CHABOT- LAS POSITAS COMMUNITY COLLEGE DISTRICT

Addendum No. 1 INVITATION FOR BID NO.: 10-05 Soccer Improvements - Chabot College

CHABOT SOCCER IMPROVEMENTS
ADDENDUM # 1
NEW SCOREBOARD LOCATION

DA1.0

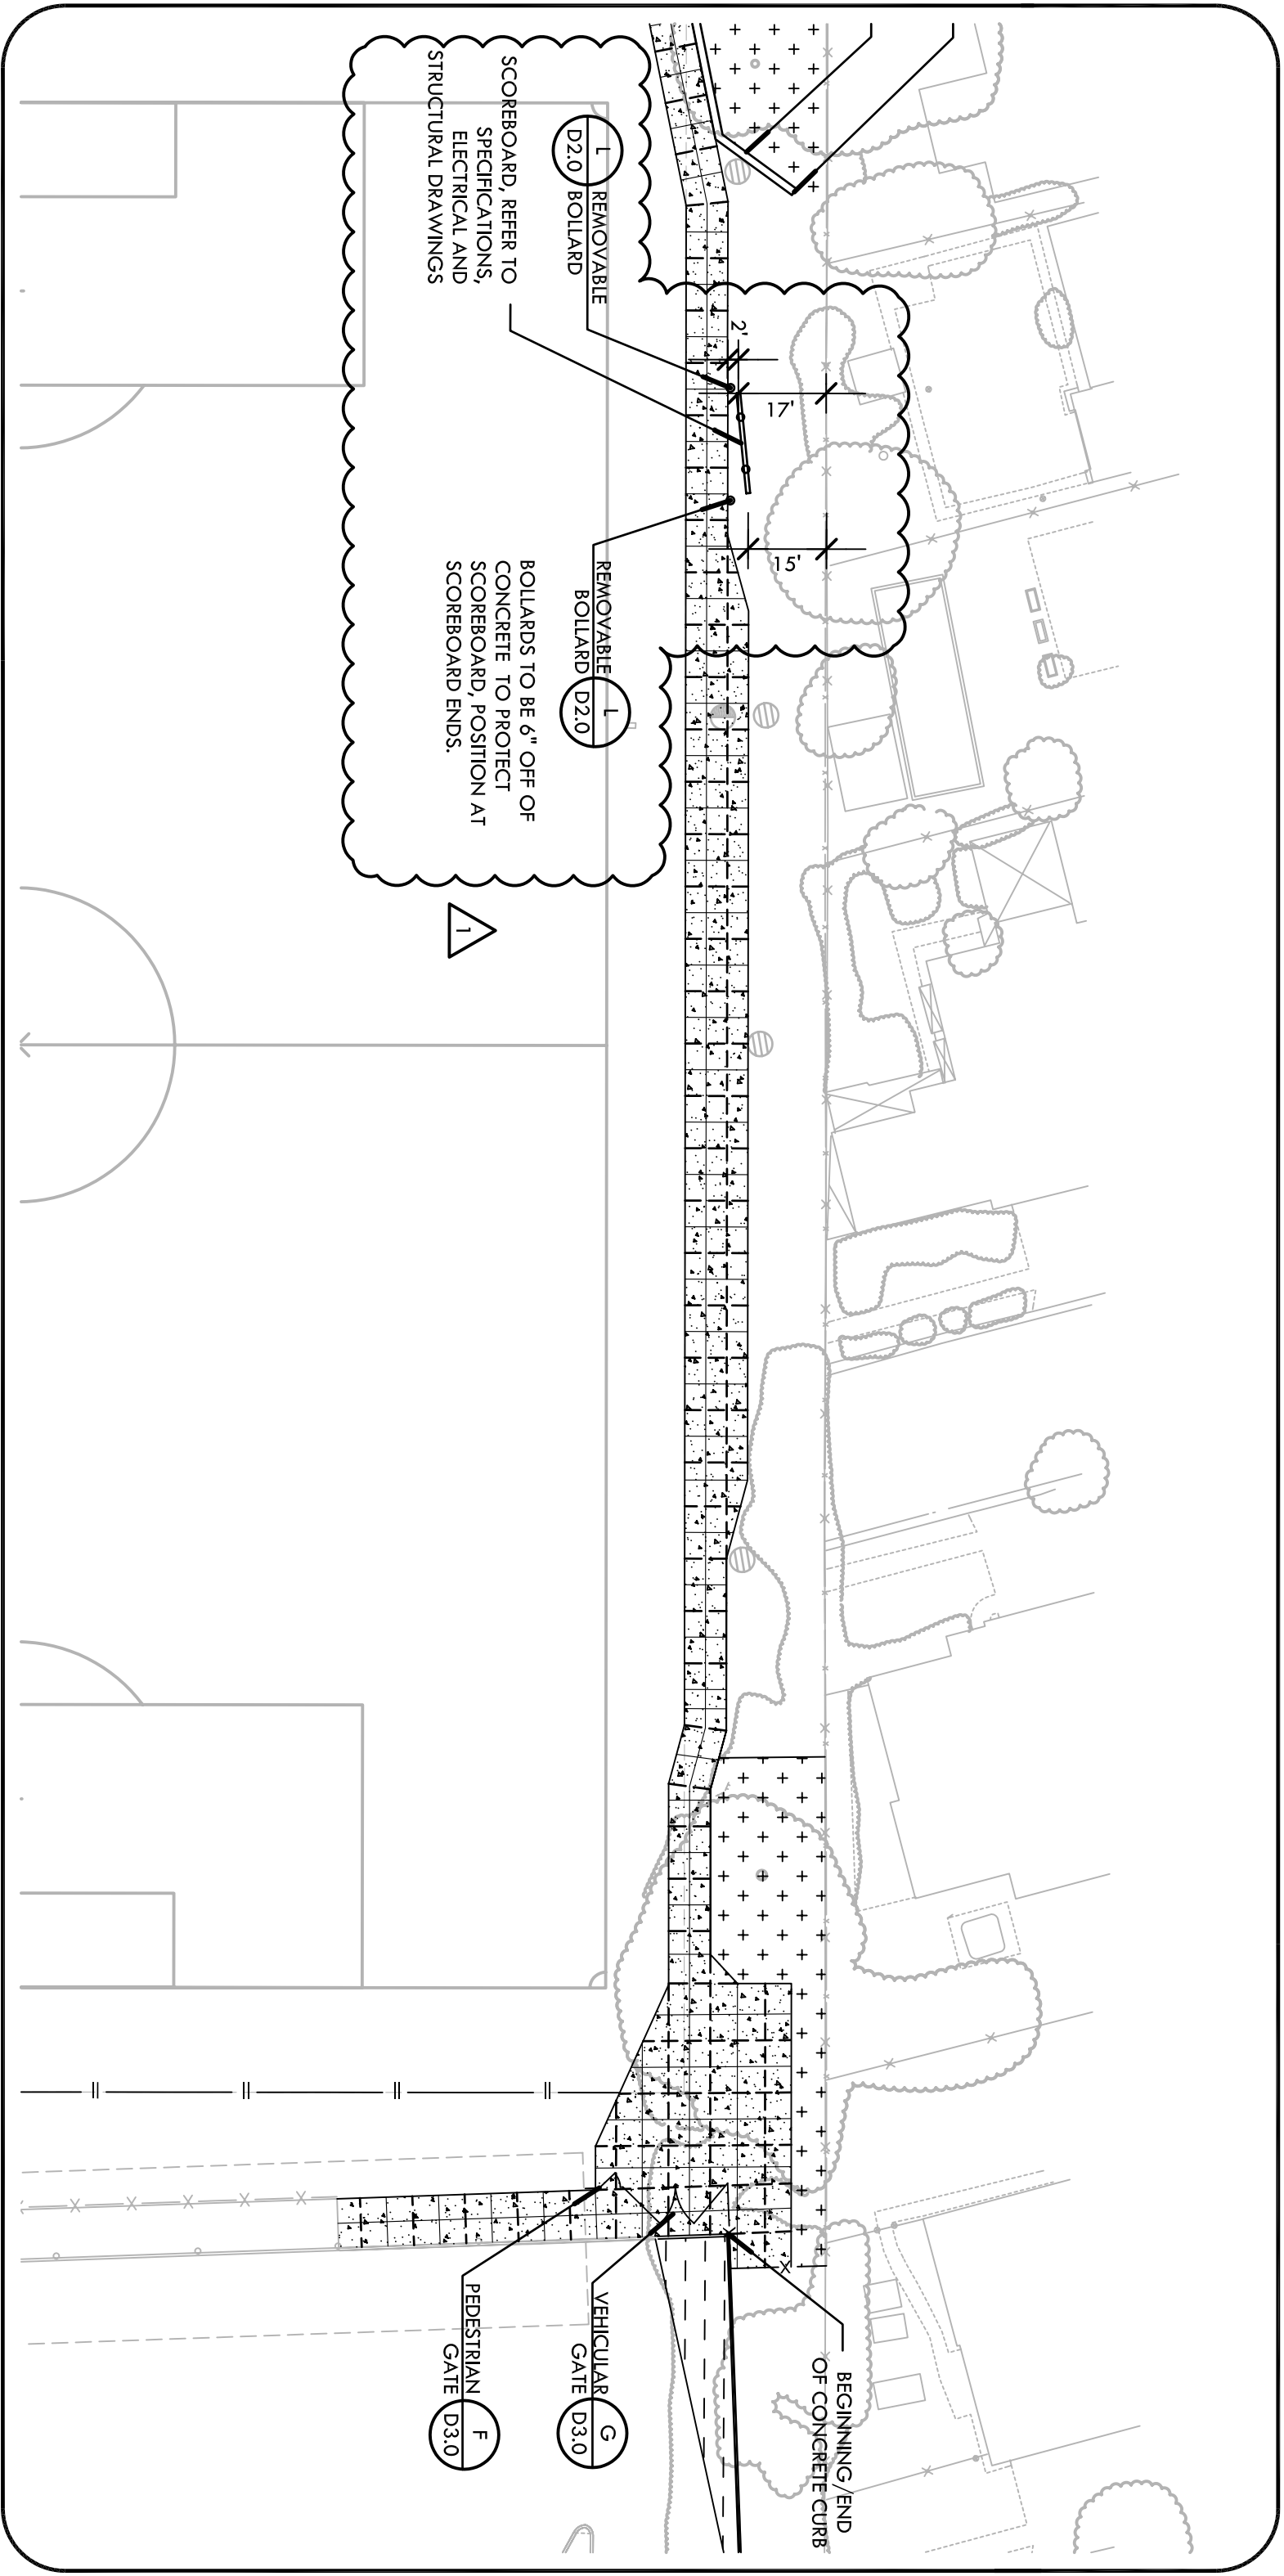
1-6.	Sheet C7.0 and E1.1	<p>The location of scoreboard has been changed as shown on the attached Drawing Attachment #1 to a point between the northwestern property line and the new concrete walkway. Electrical changes for underground Conduit Routing/Requirements are shown on Drawing Attachment SKE-1.</p> <p>Revise Sheet E1.1, Note #2 to read: “Provide and install (N) Sportsfield Specialties COM BOX 3500 in turf , flush against concrete walk with artificial infill turf kit pre-installed at the factory. Provide and install dedicated power connection for scorer’s table (one circuit to serve both locations). Contractor shall coordinate exact location and requirements with Architect. Refer to Detail #3, E2.1 for further requirements. Route (3) #4 AWG wires back to (E) 208Y/120V Panelboard located in Substation “E,” via (E) and (N) underground conduits shown. Contractor shall provide (N) 20A/1P dedicated circuit breaker in panelboard’s available space. Contractor shall verify and match (E) panel’s AIC, Type and Frame-Style.” REVISE Sheet Note # 3 to read: “Provide and install dedicated power connection for irrigation controller. Contractor shall coordinate exact location and requirements with irrigation controller installer. Route (3) #6 AWG wires back to (E) 208Y/120V Panelboard located in Substation “E,” via (E) and (N) underground conduits shown. Contractor shall provide (N) 20A/1P dedicated circuit breaker in panelboard’s available space. Contractor shall verify and match (E) panel’s AIC, Type and Frame-Style.” REVISE Sheet Note # 5 to read: “Provide Nema-3R junction boxes for power and signal at new scorboard. Contractor shall connect power and controls as required. Route control cable in signal</p>

SKE-1

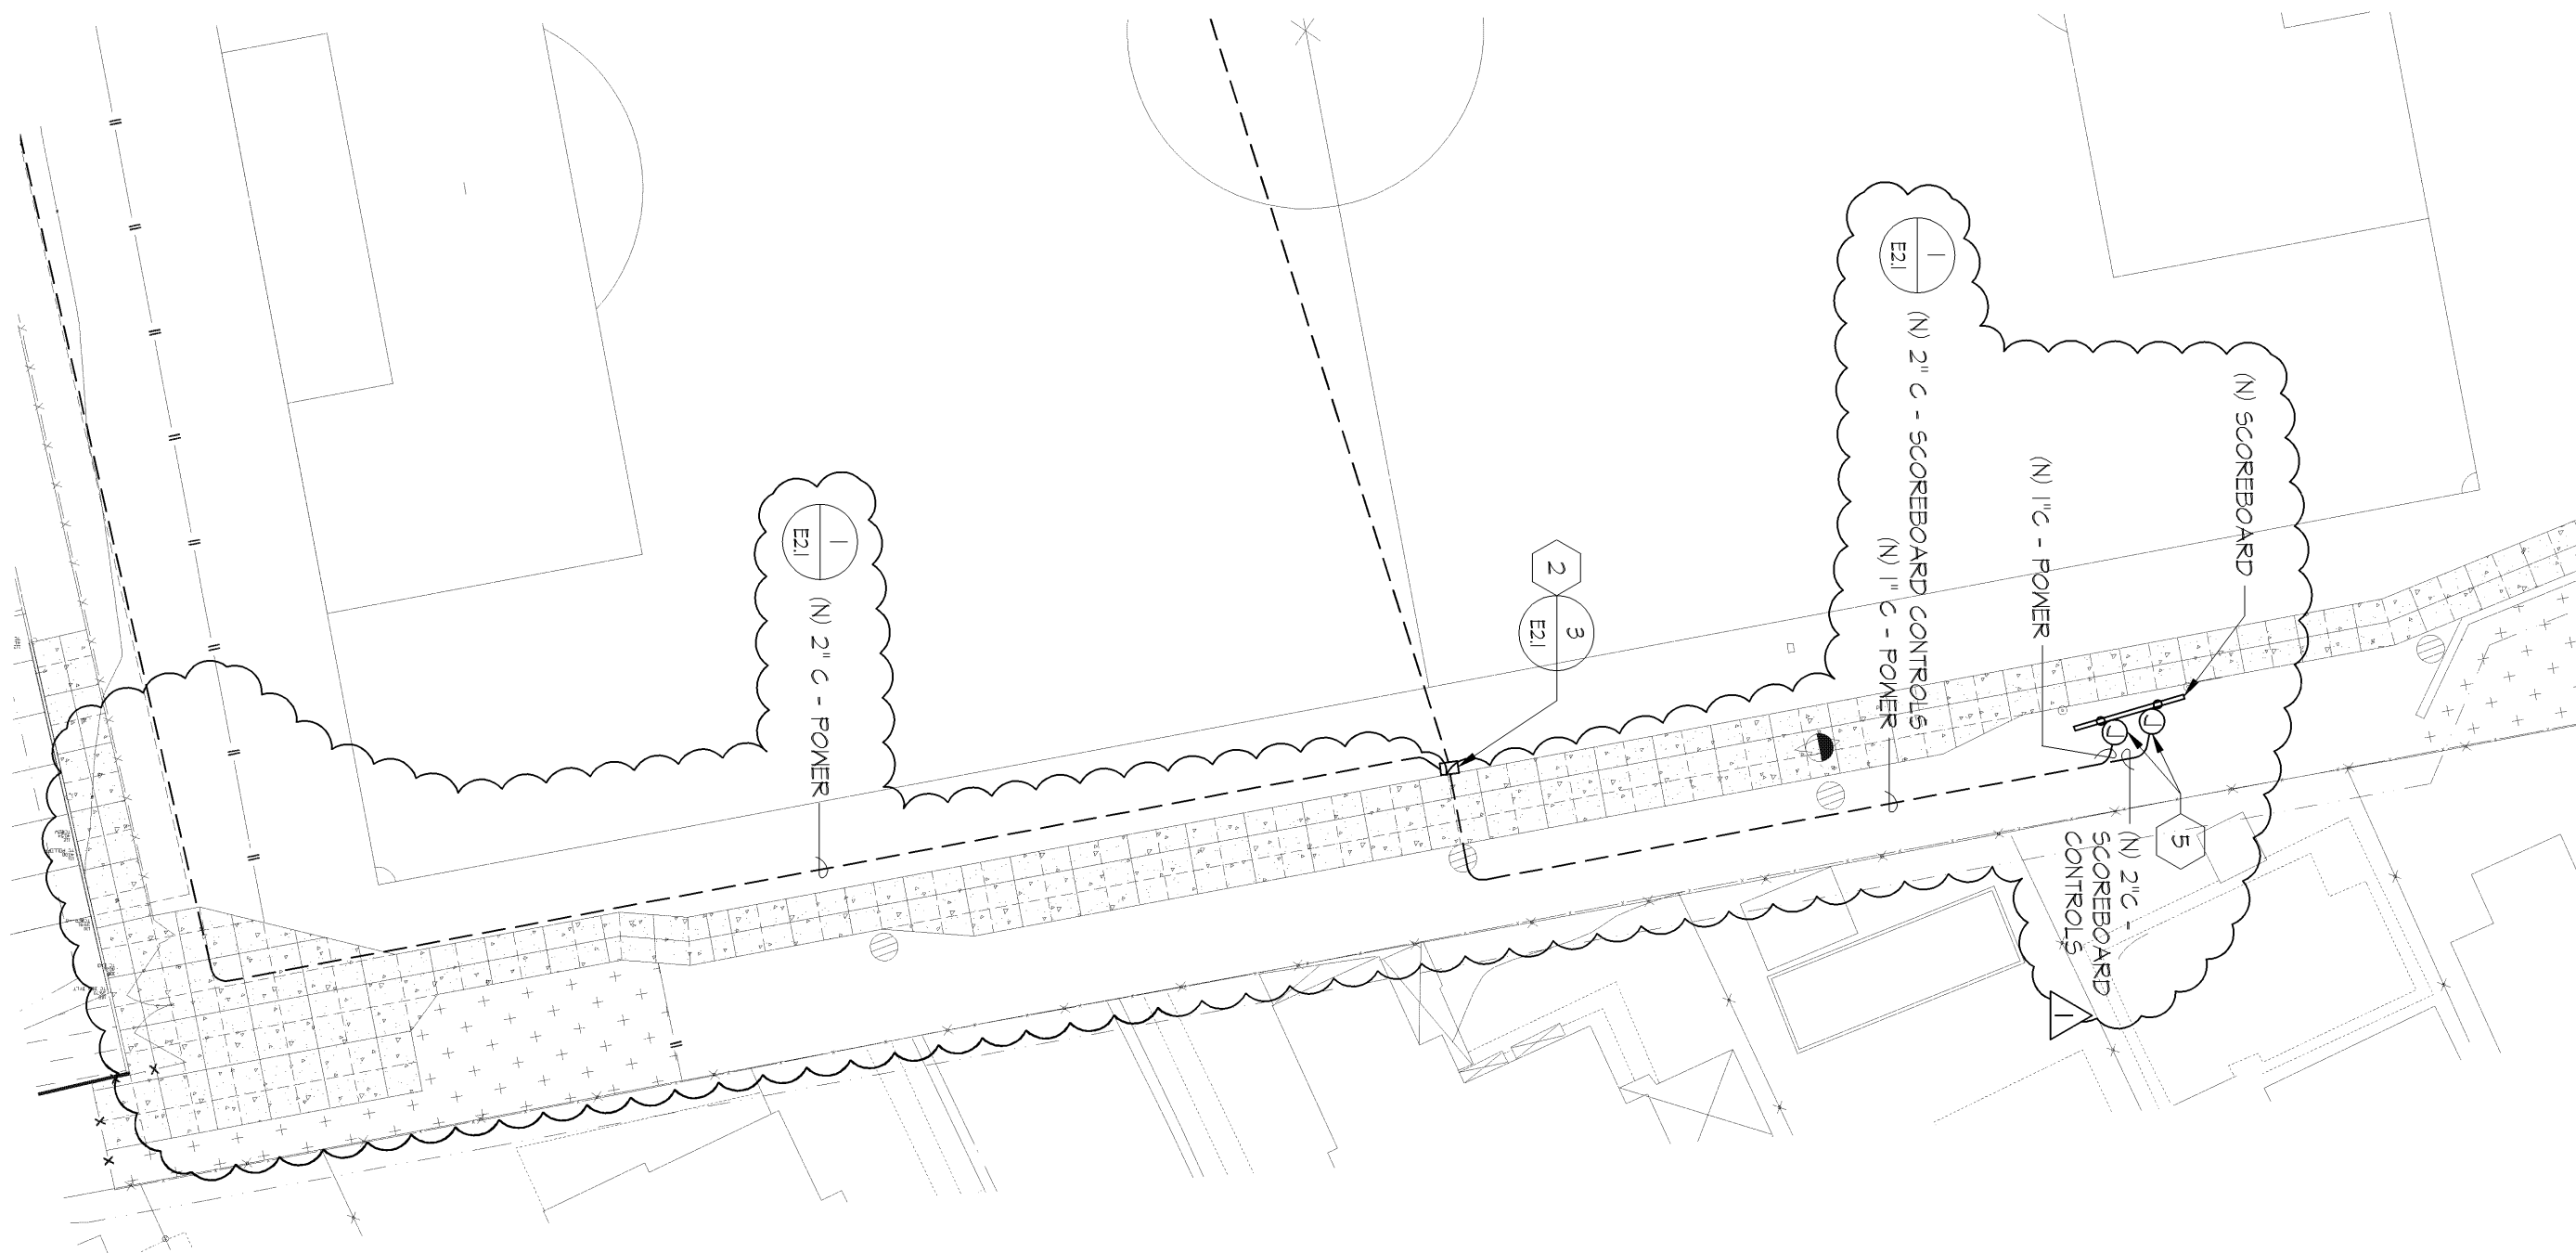
conduit shown back to scorer's table in-grade pull box locations. Provide control cable per scoreboard manufacturer's recommendation. Provide and install dedicated power connection for scoreboard. Contractor shall coordinate exact location and requirements with scoreboard installer. Route (3) #4 AWG wires back to (E) 208Y/120V Panelboard located in Substation "E," via (E) and (N) underground conduits shown. Contractor shall provide (N) 20A/1P dedicated circuit breaker in panelboard's available space. Contractor shall verify and match (E) panel's AIC, Type and Frame-Style."
1-7.	Sheet C8.0, Irrigation Legend, Mainline.	Mainlines 3" and smaller, shall be Purple-NP ASTM D-2241 PVC DR 13.5, (Pressure Rating 315 PSI), Solvent weld. Mainlines 4" and larger, shall be Purple-NP AWWA C900 DR14 (Pressure Class 200 PSI) with Ductile Iron fittings and mechanical joint restraint conforming to ASTM F1674 as follows. Straight C-900 PVC Bell fittings shall receive JCM Industries, Inc. 620 Sur-Grip Joint Restrainer or approved equivalent. Ductile iron fittings shall be restrained with JCM Industries, Inc. 610 Sur-Grip Fitting Restrainers or approved equivalent. All Restrainers shall receive two layers of Bituminous Coating. Thrust blocks shall be installed per Sheet D4.0, Detail B.
